**Bid Bulletin No. 1**

**RFQ 324/20 Supply and Installation of RO system in Baiji General Hospital**

**UNDP response to Request for clarifications**

Layout drawing for R.O system

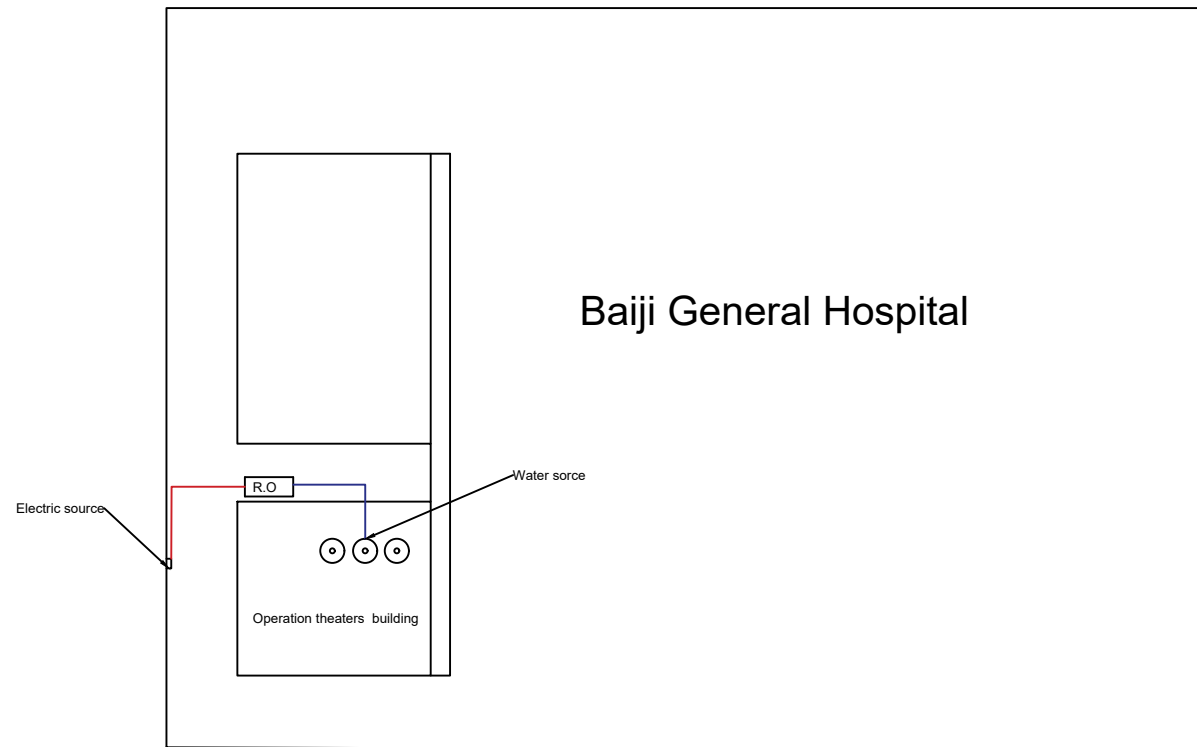
**Q1)- Please share the Layout Drawing where you want the installation to be done.**

**Attached.**
